Dog Village, Broadclyst Shared-Use Path

Report of the Director of Climate Change, Environment and Transport

Devon County Council (Various Roads, Dog Village) (No Waiting At Any Time) Amendment Order ENV:6147

Appendix 2 to CET/24/114

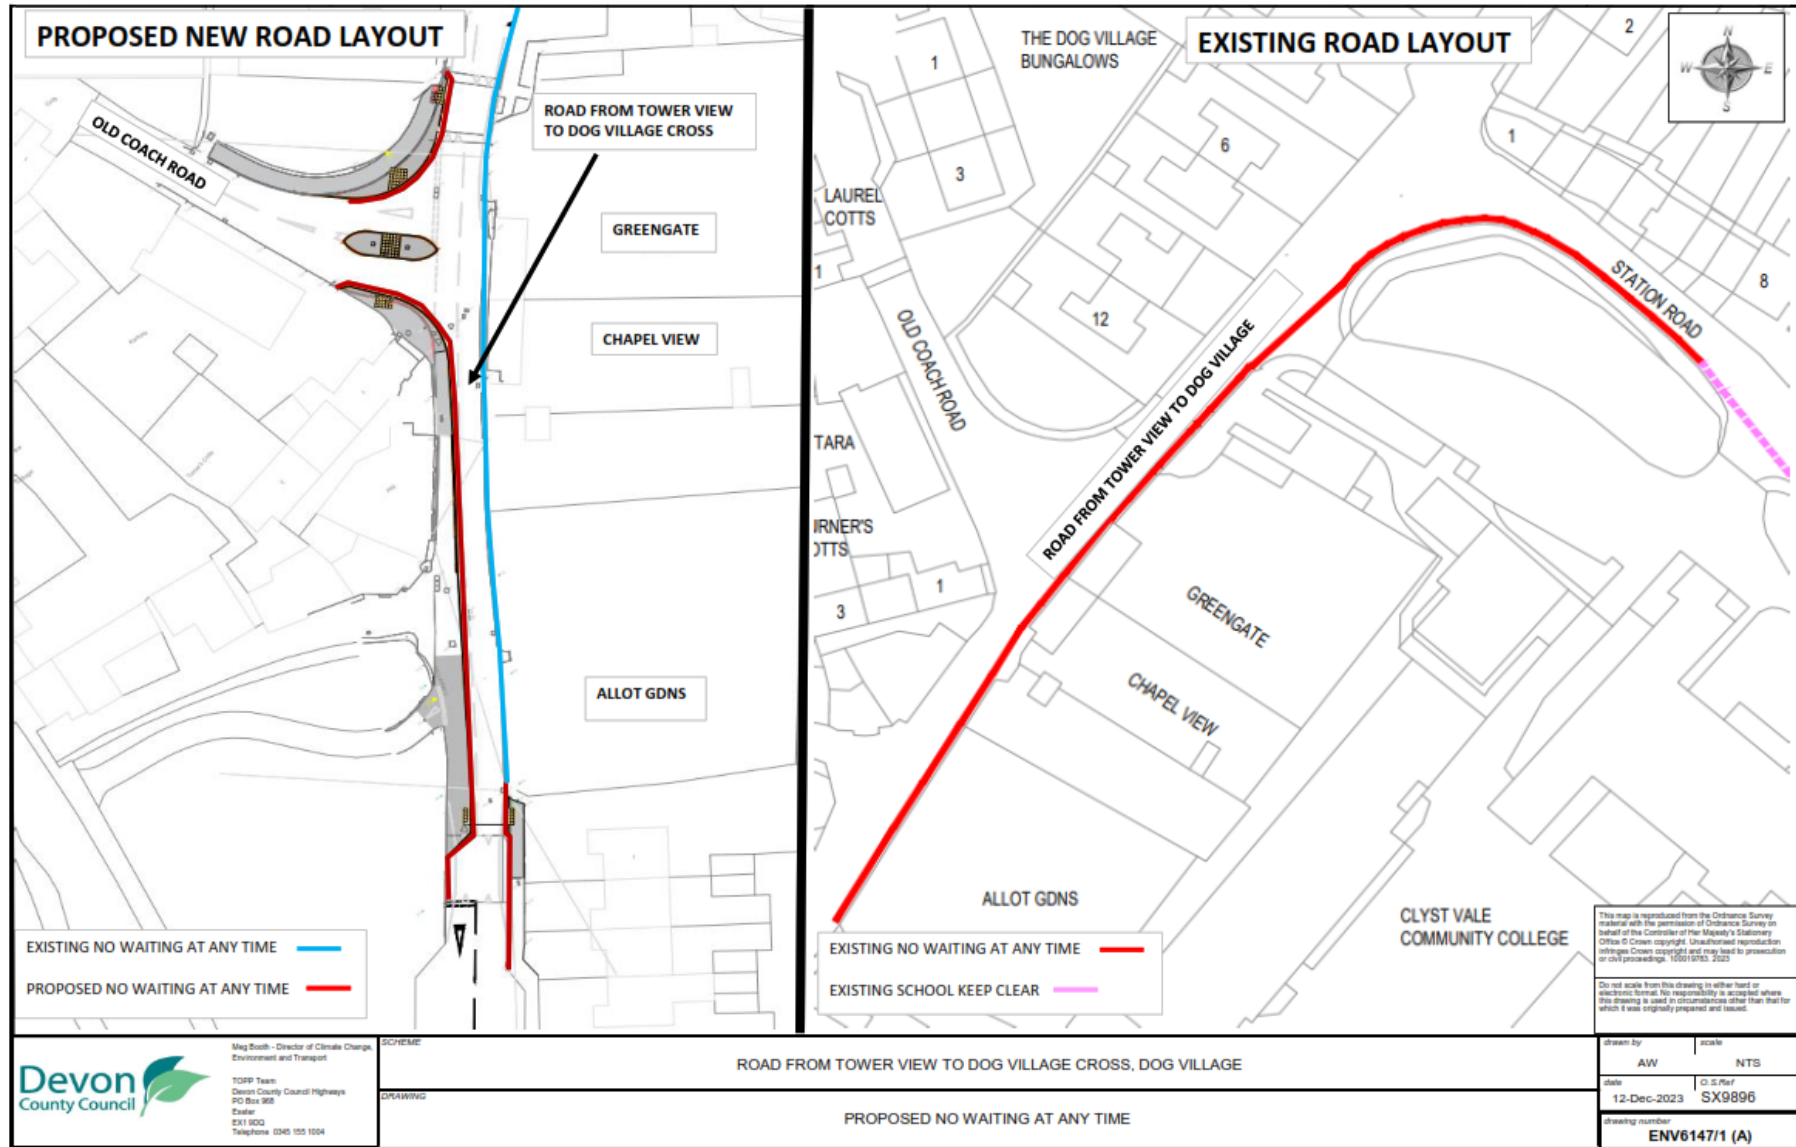
Comment	DCC Response
First Respondent: Dog Village	
<p>I approve of the proposed amendment order as walking or driving in the village around school drop off/collection is becoming increasingly dangerous. I am however concerned about the likely influx of traffic to the private road Tower View. We already experience a great deal of 'school drop off' traffic in Tower View, and I think it is likely that this amendment will result in an increase of inappropriate traffic on a residential private road. The Tower View road is totally unsuitable for an increased rate of traffic, and there would likely be dangerous bottlenecks at the T junction leaving the road. Please could you advise on how this has been factored in to the amendment order, and how the residents should manage the trespassing concerns listed above.</p>	<p>As Tower View is a private road, it is not a highway maintainable at public expense, and therefore responsibility for the upkeep and management of this road rests with the people whose properties front onto them.</p>

<p>Approves proposals as walking or driving in the village is becoming increasingly dangerous.</p>	<p>Support noted.</p>
Second Respondent: Dog Village	
<ol style="list-style-type: none"> 1. Removing the current on street parking will open up the road and encourage faster traffic speeds in the area. 2. The proposed restrictions appear to remove the main/only area of on street parking at Dog Village. What provision is being made for alternative parking 	<ol style="list-style-type: none"> 1. The proposed changes to waiting restrictions are proposed to be delivered in conjunction with a scheme to deliver additional footways on Road from Tower View to Dog Village Cross, with a Priority System introduced. Hence the removal of parking, as otherwise the parked vehicles would obstruct the highway. Also, the proposed footway and virtual footway will reduce the width of the road to single-file, which is likely to encourage vehicles to slow down. 2. Additional on-street parking is available nearby, including on Old Coach Road and adjacent streets. The potential disbenefits to people currently parking on Road from

<p>for the (on average) 9 - 12 residents cars that are parked here.</p> <ol style="list-style-type: none"> 3. The main issue at school drop off and pick up times is parental parking: this is transitory and the likelihood is that parents will ignore the restrictions for the very short time that they are in the area whilst the residents will be adversely impacted 7x24. 4. Why do the restrictions need to extend beyond into the area where there is already pavement provision in front of Tower View. 5. Could we not look at other options such as residents parking, priority traffic flow or even a one way traffic flow around Dog Village. 	<p>Tower View to Dog Village Cross are considered proportionate to the potential significant safety benefits of the scheme to deliver additional footways.</p> <ol style="list-style-type: none"> 3. With the introduction of the proposed road narrowing and Priority System there would not be a space for cars to park in the affected areas at any time without obstructing the highway and/or presenting a danger to other road users. 4. The proposed restrictions are to ensure the vehicles are not parked/ obstructing the proposed priority system. Therefore, the restrictions are extended beyond the entrances to the Priority System. 5. As advised in relation to point 1, a Priority System is being proposed on Station Road.

<p>Third Respondent: Dog Village</p>	
<p>I can appreciate the proposal to make the road system described in this order however, this proposal does nothing to reduce the speed of vehicles passing through the village. It will allow those road users who abuse the 20mph restrictions on this section of road to travel faster than they do at the moment. Average speeds along this section of road exceed this restriction, in the majority of instances by at least 10mph and in other instances 30 to 40 mph. Thus making the transit of pedestrians more dangerous along this section.</p> <p>Also by implementing this TRO more than ten vehicle parking spaces will be lost. There is insufficient parking available in the village for those residences which have no allocated parking space, so where will those residents park?</p>	<p>Our proposal is to have Priority System on the Station Road with the priority given to the outbound traffic towards B3181. Also with the introduction of proposed footway and virtual footway, width of the carriageway which should reduce the speed of the vehicles passing though the village.</p> <p>Additional on-street parking is available nearby, including on Old Coach Road and adjacent streets. The potential disbenefits to people currently parking on Road from Tower View to Dog Village Cross are considered proportionate to the potential significant safety benefits of the scheme to deliver additional footways.</p>
